**DEVIATION REQUEST
AND DECISION FORM**

Project Name : The Glen at Widefield Filing No. 11
 Schedule No.(s) : 5522000009, 5522000007
 Legal Description : See Attached Document

A deviation from the standards of or in Section **ECM 2.3.3.F.3** of the Engineering Criteria Manual (ECM) is requested.

EXHIBIT 1

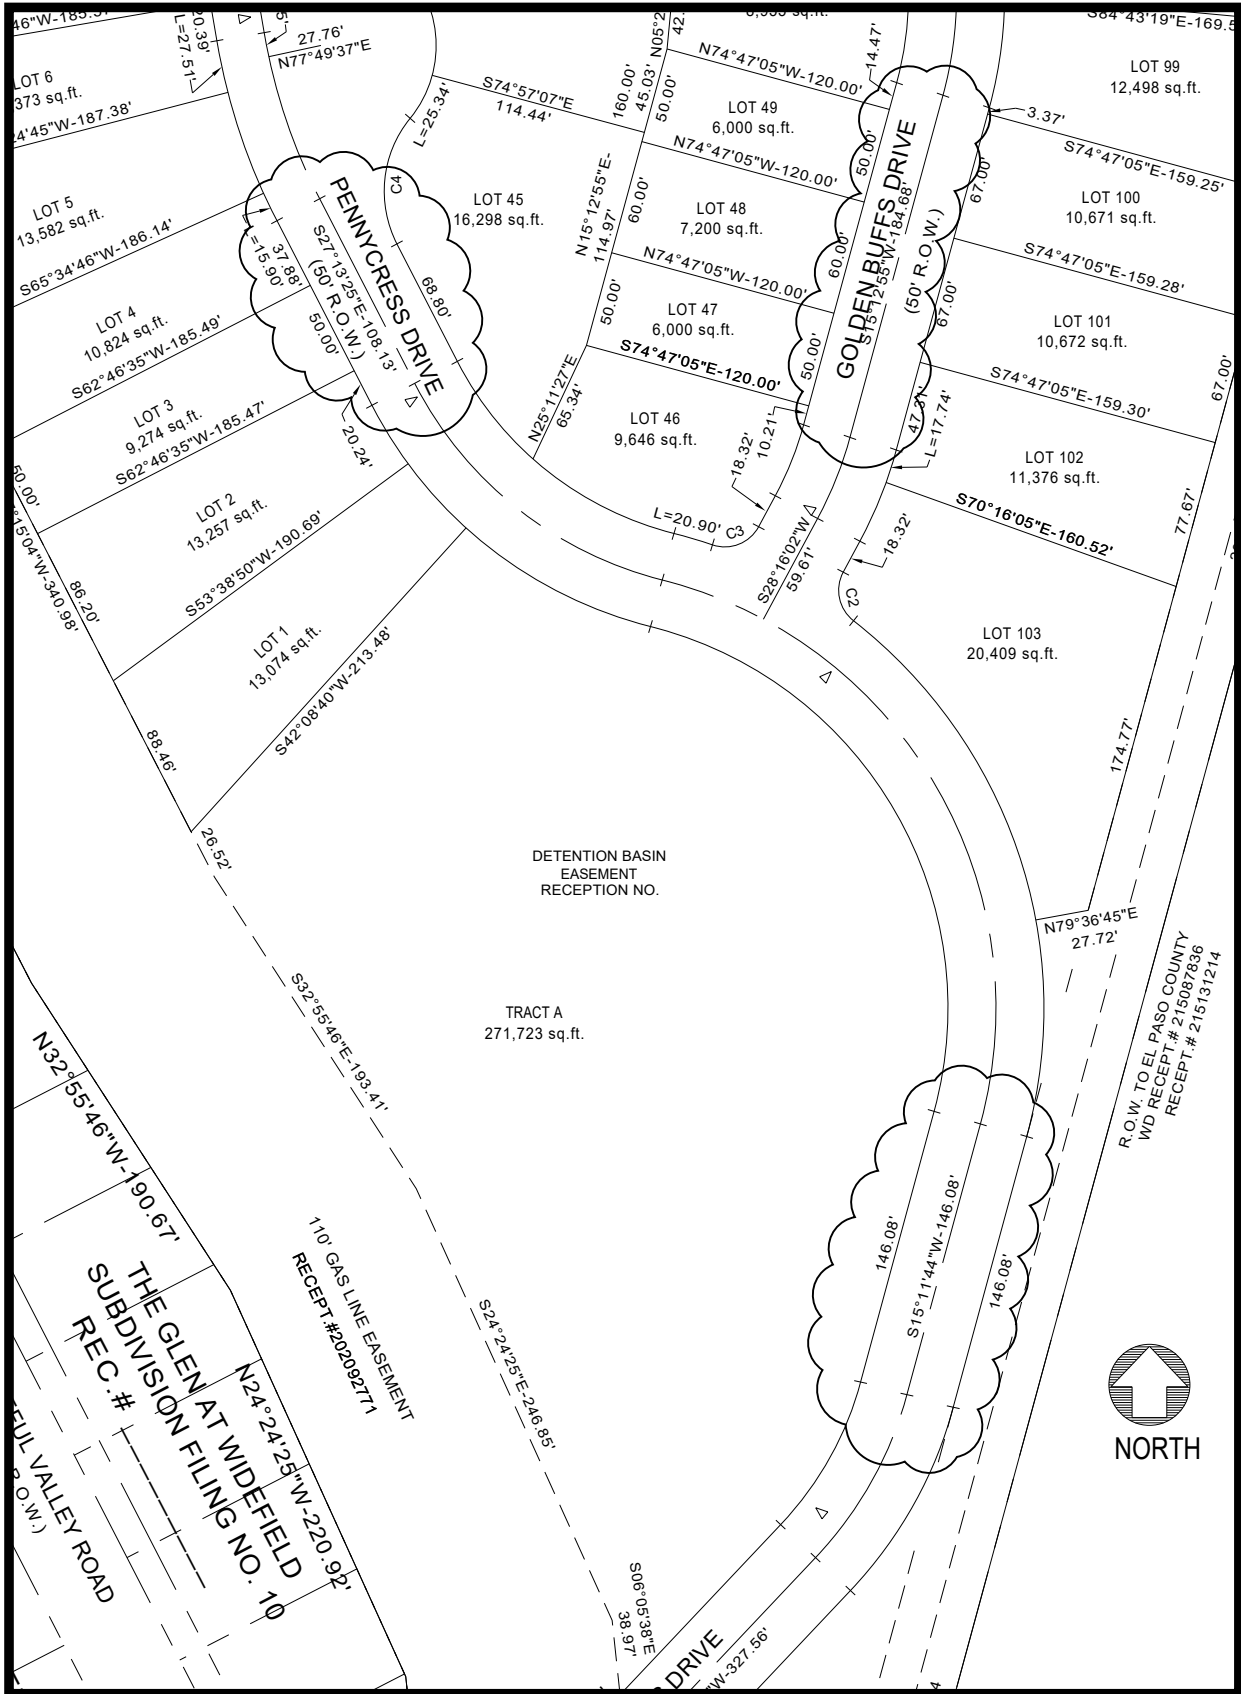
The Deviation is requested in the three locations shown on the plat. Two locations on Pennycress Drive in the south end of the subdivision and the third is on Golden Bluffs Drive near the intersection of Pennycress Drive. This section of the plat has a constricted geographic triangular shape due to an existing large gas line which converges with the Marksheffel Road Right-of-Way. The tangent sections are less than 200 feet, but they were laid out in order to make the streets and lots in this area as efficient as possible and in the case of the Golden Bluffs Drive section the tangent section is shorter so that a horizontal curve can be provided at the south end that allows the intersection of Pennycress Drive and Golden Bluffs Drive to be 90 degrees, thus avoiding a non-radial intersection. In order to lengthen the tangent sections along Pennycress Drive we would need to tighten the horizontal curve radii which would make the drivability less than ideal. In cases where we could increase the curve lengths to create a large sweeping reverse curve there is a possibility that we would make the adjacent lots unbuildable.

The current design as submitted with the broken back curves occur on low traffic volume local streets. We have used the same types of curve and street geometry throughout the City of Colorado Springs and they are allowed, approved and function safely and adequately throughout the City. The lengths of the tangents on the three locations are as follows. The two sections on Pennycress Drive are 108.13' and 146.08'. The section on Golden Bluffs is 184.68'. These distances are below the 200' minimum as specified in the ECM standards. Please refer to Exhibit 1 attached to this document.
